**AERONAUTICAL CHARTING FORUM**  
**Instrument Procedures Group**  
**April 28, 2009**  
**HISTORY RECORD**

**FAA Control # 09-01-283**

**Subject:** Intermediate Fix Altitudes & ILS Glide Slope

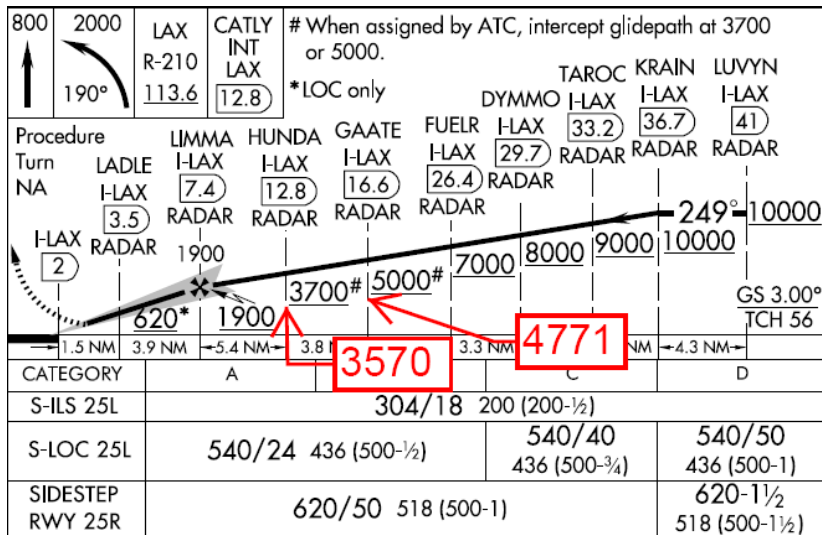
Should the pilot elect to intercept and track the ILS glide slope at a point prior to the glide slope interception altitude, this action does not necessarily ensure that subsequent fixes will be crossed at or above the published minimum crossing altitude, an expectation which is stated in AIM 5-4-5 (b)(1). An example of this situation may be seen on the ILS 25L at Los Angeles, CA (LAX) as depicted below:

The estimated ILS glide slope MSL crossing altitudes (depicted by red boxes) for the intermediate fixes GAATE and HUNDA clearly show that the ILS glide slope may not cross the fix at or above the published minimum crossing altitude. This situation is further exacerbated during conditions where higher than standard temperatures induce significant altimetry errors, a common situation in the Los Angeles basin during the summer months. Warm temperature altimeter errors result in an even greater difference between the barometric fix crossing altitude resulting from tracking the glide slope and the published minimum crossing altitude for each fix.

To ensure that pilots thoroughly understand the appropriate use of the glide slope during an ILS approach, NBAA suggests adding to AIM section 5-4-5-b the following additional paragraph:

5. The ILS glide slope is intended to be intercepted at the published glide slope intercept altitude, which is depicted by the "lighting bolt" symbol on US Government charts. Intercepting the glide slope at this altitude marks the beginning of the final approach segment and will provide required obstacle clearance from the glide slope intercept altitude to lowest published decision altitude for the approach. Interception and tracking of the glide slope prior to the glide slope interception altitude does not necessarily ensure that minimum, maximum, and/or mandatory altitudes published for any preceding fixes in the intermediate segment will be complied with during the descent. If the pilot chooses to track the glide slope prior to the glide slope interception altitude, they remain responsible for complying with published altitudes for the intermediate fixes encountered during the subsequent descent.

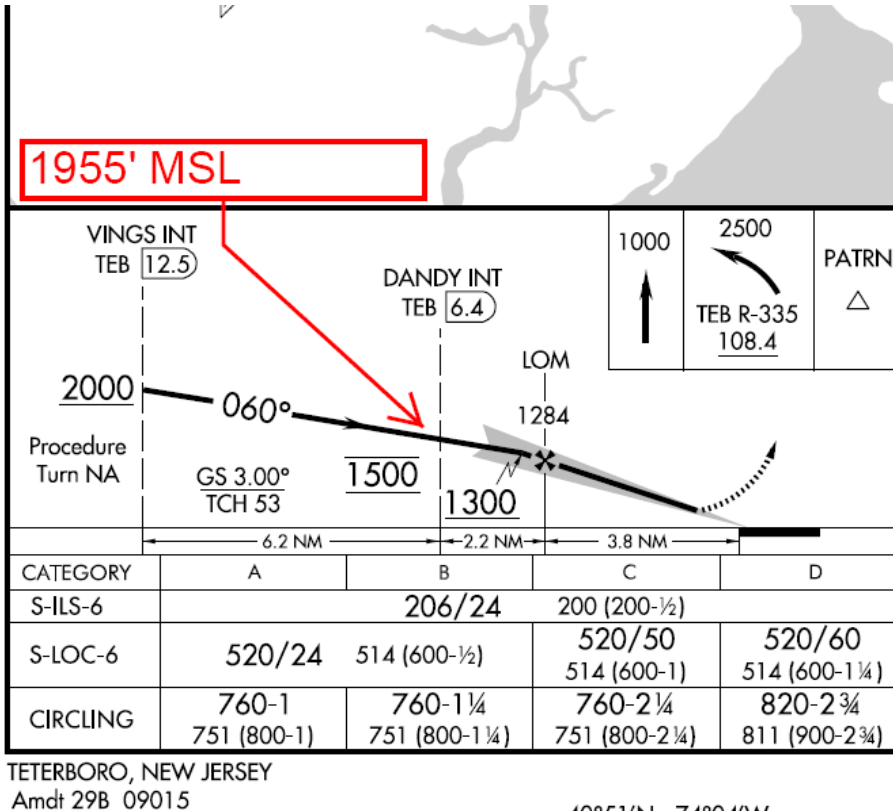
When cleared for the approach, quite often the pilot will intercept and track the ILS glide slope at the earliest opportunity perhaps believing that the glide slope will ensure that published fix crossing altitudes will be achieved. However, this practice has resulted in numerous pilot deviations of the mandatory 1,500 ft MSL crossing altitude published at DANDY intersection on the Teterboro, NJ ILS RWY 6 approach:

As can be seen in the above example, the ILS glide slope crosses DANDY well above the published mandatory altitude.

The discussion centered primarily on the Teterboro, NJ ILS RWY 6 IAP. The procedure has a minimum intermediate fix (IF) (VINGS) altitude of 2000 and specifies a mandatory IF stepdown fix (DANDY) altitude of 1500, prior to the 1300 GS intercept altitude. Pilots routinely, upon receiving clearance for the approach, intercept and fly the GS at 2000, thus missing the mandatory 1500 restriction, which is established to provide vertical separation with aircraft arriving Newark. Various chart notes and ATC clearance phraseology were discussed. Gary Fiske, AJT-28, stated that most controllers at Newark include the phrase "cross DANDY at 1500" in the approach clearance; however some pilots still opt to fly the GS and miss the restriction. Ted Thompson, Jeppesen, stated that his research indicated the procedure coding is correct. Ted added that Jeppesen's representation of the ILS GS intercept in the profile illustrates the unique 1500 foot mandatory crossing altitude below the GS at DANDY. This charting methodology received favorable comment. The Jeppesen depiction was the direct result of a Non-Standard Special Revision Order requested separately, by a representative of the FAA. Brad Rush, AJW-372, mentioned that the problem could possibly be resolved by revising the IAP lateral track and profile and he will have the procedure developers for Teterboro check into it. Dan Diggins, AJT-28, stated that he believes an FAA safety inspection to review Teterboro is scheduled. Tom Schneider recommended that AFS-410 review the NBAA original recommendation document that requested the addition of another subparagraph AIM paragraph 5-4-5-b to clarify pilot responsibilities when intercepting the GS prior to the PFAF or as assigned by ATC (see issue 09-01-282). **ACTION: AFS-410 and AJW-372.**
